To: T10 Technical Committee  
 From: Rob Elliott, HP (elliott@hp.com)  
 Date: 19 June 2002  
 Subject: T10/02-198r3 SAS OOB timing

**Suggested Changes**

**Figure 1. ~~Phy reset sequence~~ OOB signal generation-transmission and detection**

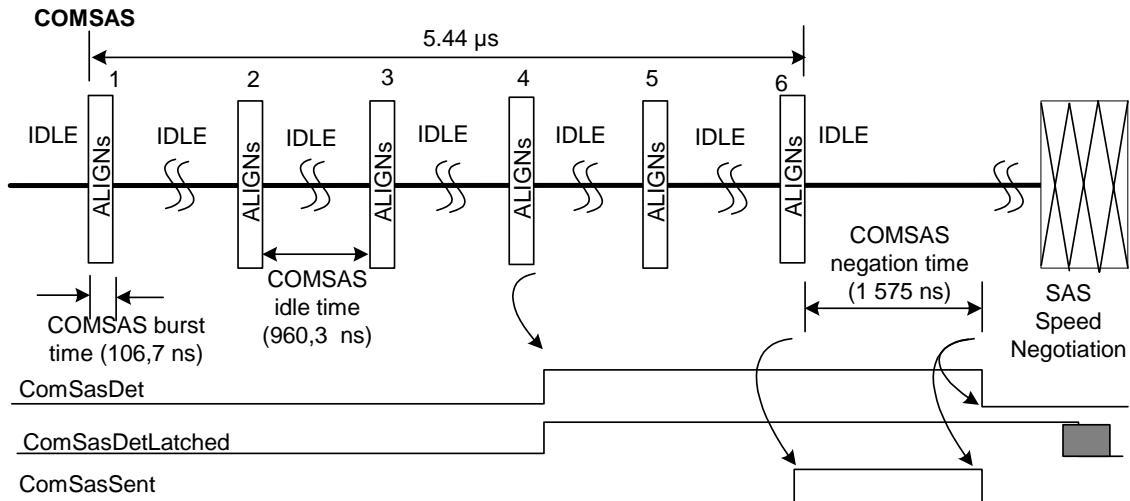
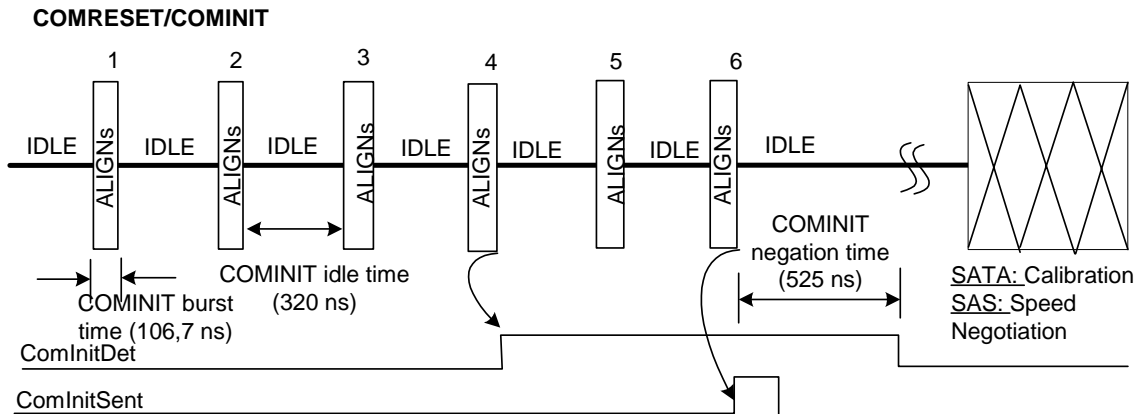
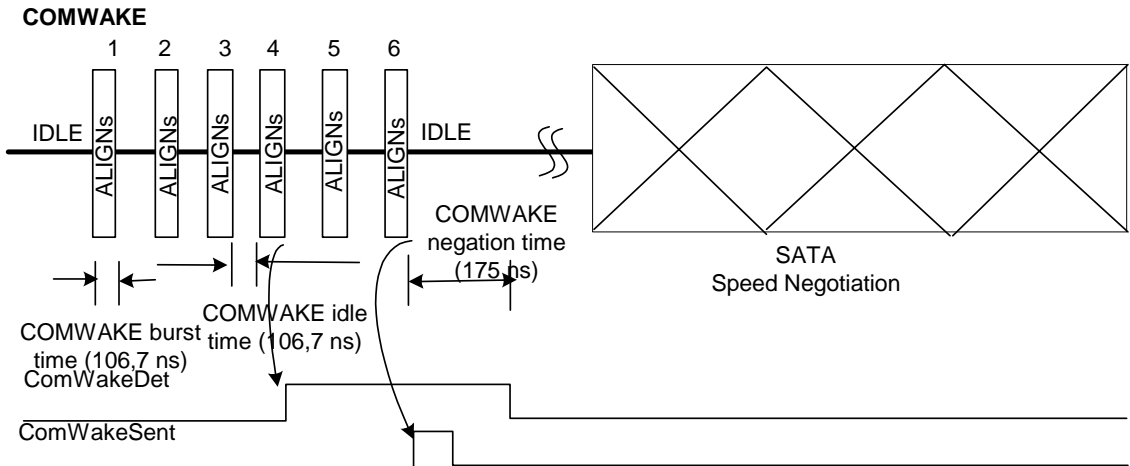
Figure 1 illustrates the timing required for the generation and detection of all the SAS OOB signals. The signals labeled ComXxxDet and ComXxxSent (where Xxx is Wake, Init, or Sas), are inputs to the SAS phy Initialization layer state machine. ComXxxDet is an output from the OOB detection circuitry that indicates the detection of an incoming COMINIT, COMWAKE, or COMSAS sequencesignal. ComXxxSent is an output from the OOB generation circuitry that indicates that a burst of six COMWAKE, COMINIT, or COMSAS sequences-signals has been output onto the link.

To send an OOB signal, a transmitter shall send the OOB signal at least six times. A receiver shall detect an OOB signal after receiving it at least four times. It shall not detect the same signal again until it has detected another OOB signal or an OOB signal negation time.

Figure 35. SAS device to SATA device phy reset sequence

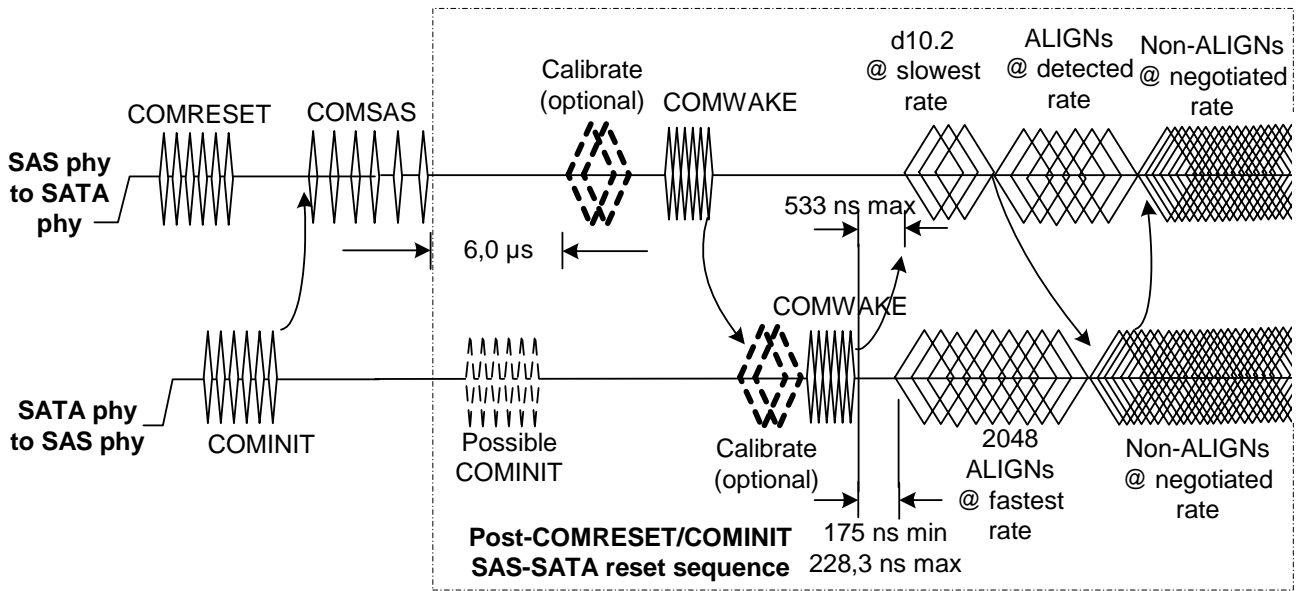
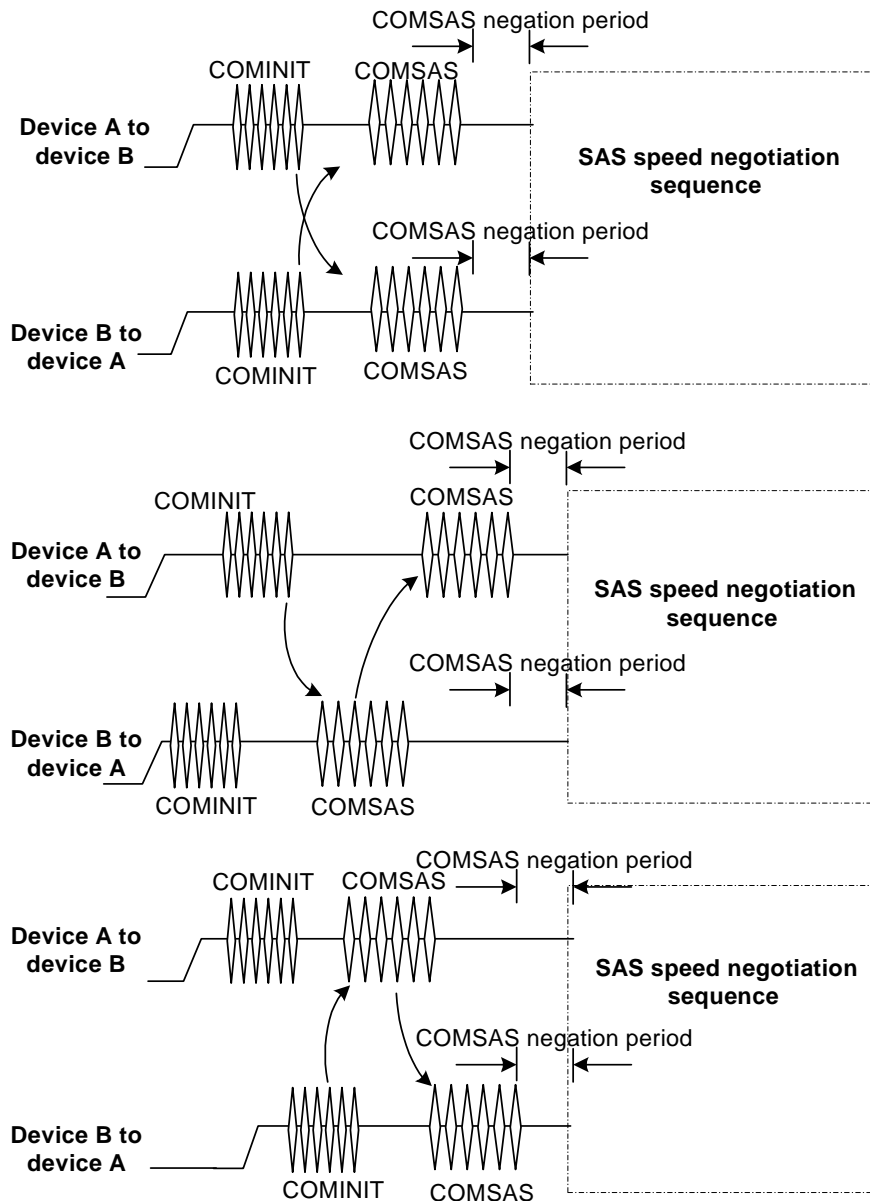
Figure 35 shows a reset sequence between a SAS phy and a SATA phy (i.e., between an expander device and a SATA target device, or between a SAS initiator device and a SATA target device). The two possible cases are presented. The first case is that a legacy SATA phy misinterprets the COMSAS to be a COMRESET and responds with a COMINIT. The second case is that the SATA phy ignores the COMSAS and provides no response within the COMSAS detect timeout of 3.5 μs. The SAS phy state machine treats these two cases the same, and determines that a SATA phy is attached. The normal SATA reset sequence shall be used thereafter.

**Figure 36. SAS-to-SAS phy reset sequence**

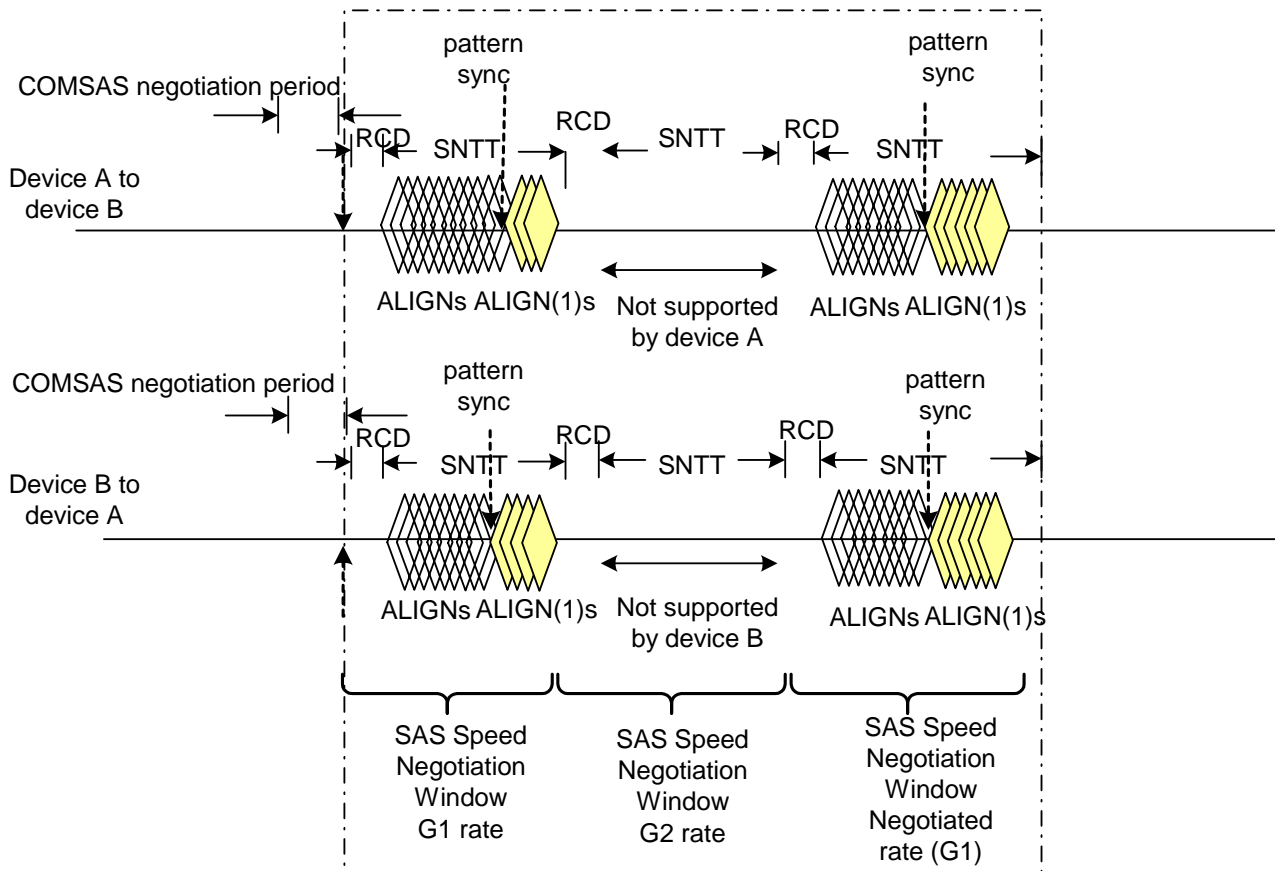
Figure 36 illustrates several different ~~power-up~~ sequences based on whether ~~one a~~ SAS phy powers up before, after, or at the same time as the SAS phy to which it is attached.

**Figure 37. SAS speed negotiation sequence (example 1-G1, G2, G3 with G1, G2)**

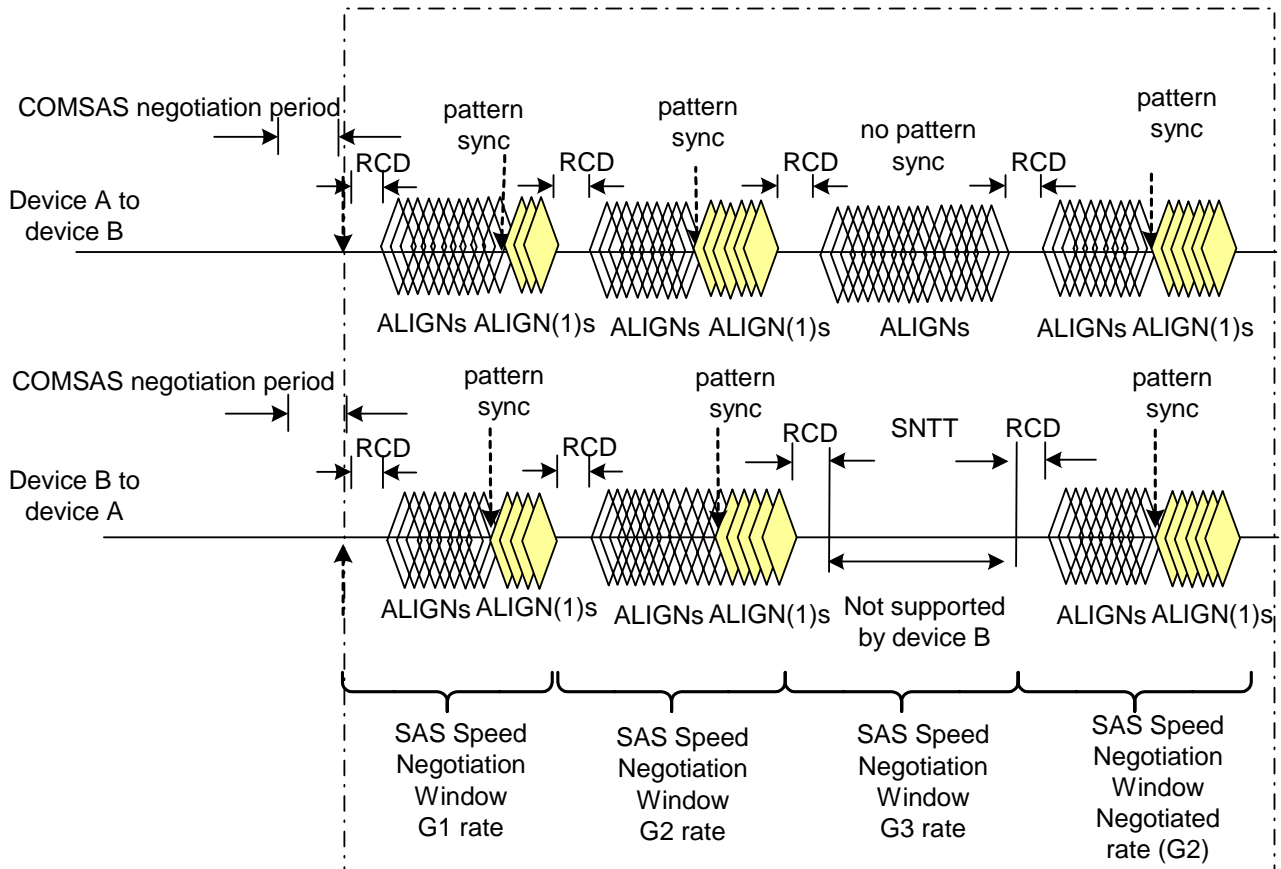
Figure 37 shows a speed negotiation between a SAS phy-device A that supports speeds-G1 thru G3 link rates attached to a SAS phy-device B that only supports speeds-G1 and G2 link rates.

**Figure 38. SAS speed negotiation sequence (example-2G1, G2, G3 with G2 only)**

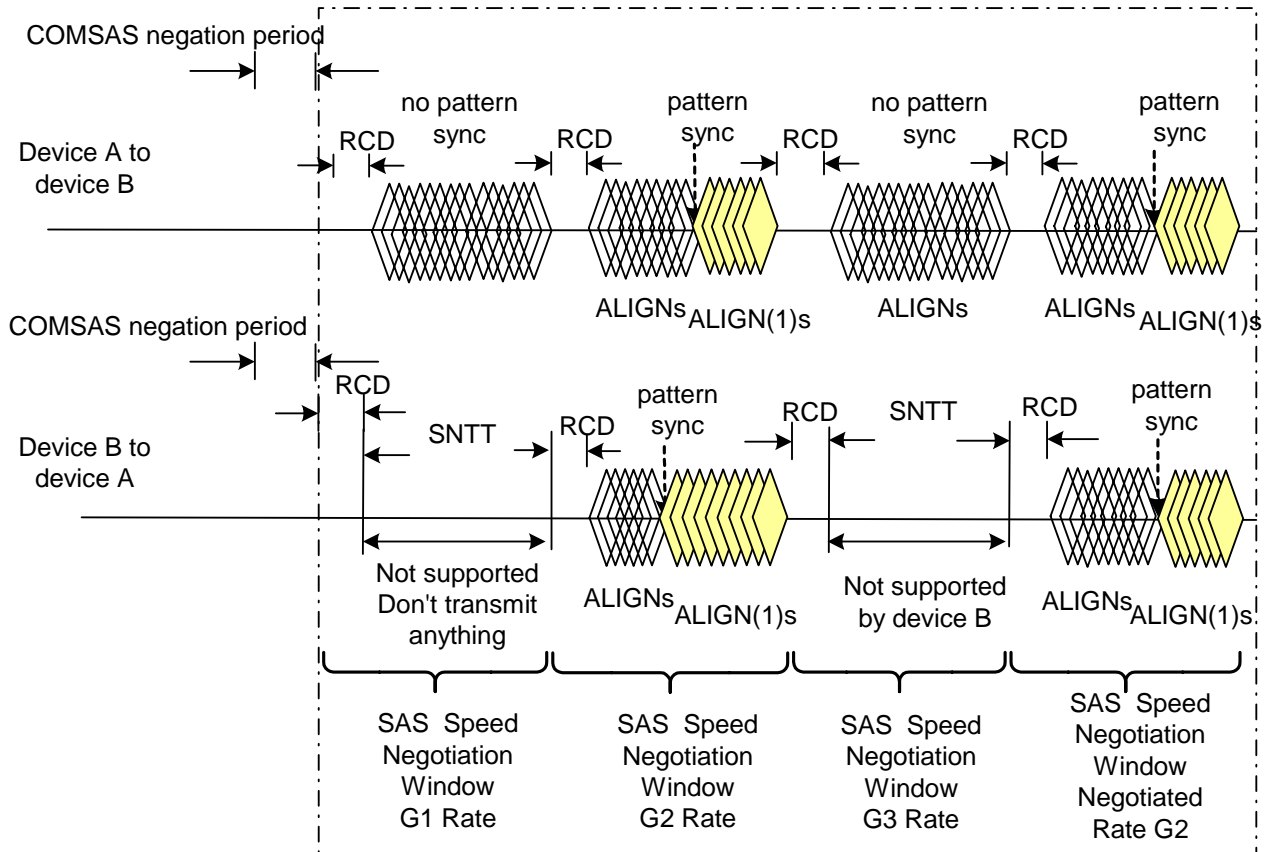
Figure 38 shows speed negotiation between a SAS device **A** that supports G1 thru G3 link rates and a SAS device **B** that only supports the G2 link rate.

Figure 39. SAS speed negotiation sequence (example 3G1,G2,G3 with G1,G2 and failure)

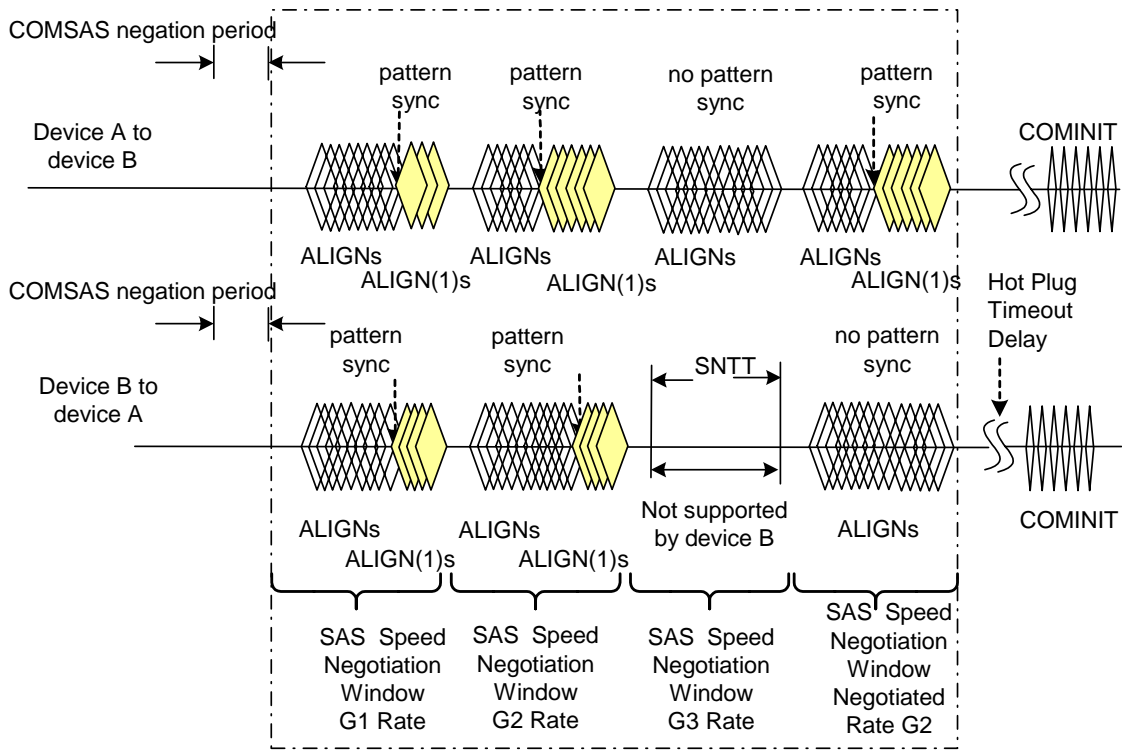
Figure 39 shows the same speed negotiation sequence as in Figure 37, except for some reason, one of the SAS device's PLLs does not obtain pattern synchronization and detect ALIGNs during the final speed negotiation window. If this occurs, the handshake is not complete and the OOB sequence shall be retried starting with COMINIT, forcing the link to retry the whole reset sequence.

Any time a SAS phy fails speed negotiation, it shall wait the Hot Plug Time-out Delay before attempting a retry.
